FIELD SERVICE BULLETIN

FSB Number: LVCCFSB2005-368
Authors: Darwin Garcia
Date: December 15, 2005
Total No. of Pages: 2
Subject: **V3 CLI Crack Driver IC**
Model Affected: **V3**
Level of Repair: 2

Point of Impact

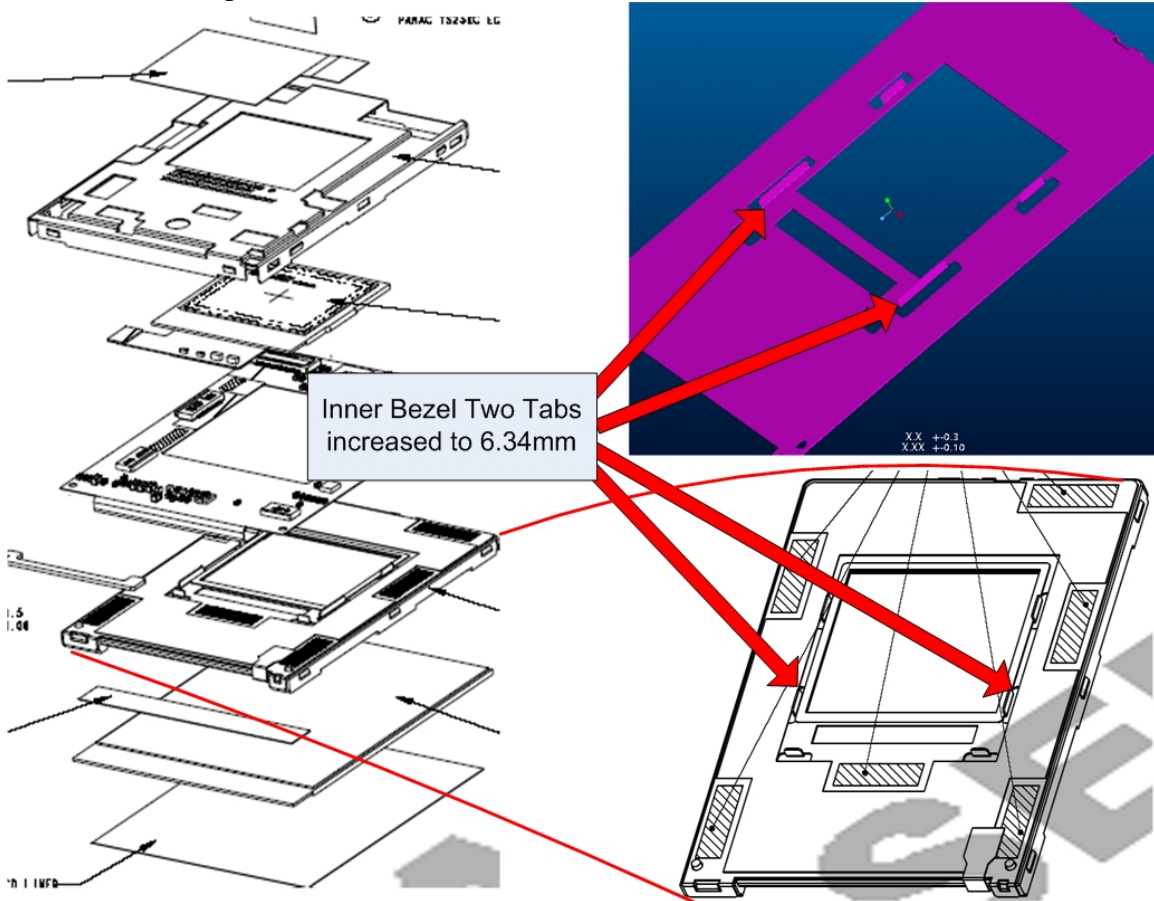
Service has been made aware of a V3 CLI crack driver IC issue causing “No CLI Display” complaints.

The cause of the crack driver IC was determined to be physical force being applied at the CLI lens.

The inner bezel design of the display module was improved by increasing the height of the two tabs that protect the CLI drive IC to 6.34mm.

The part numbers revisions change to 7290086N01 Rev D for Sanyo (cut over date 12/9/2005) and 7290086N02 Rev A for Sharp (cut over date 12/2/2005).
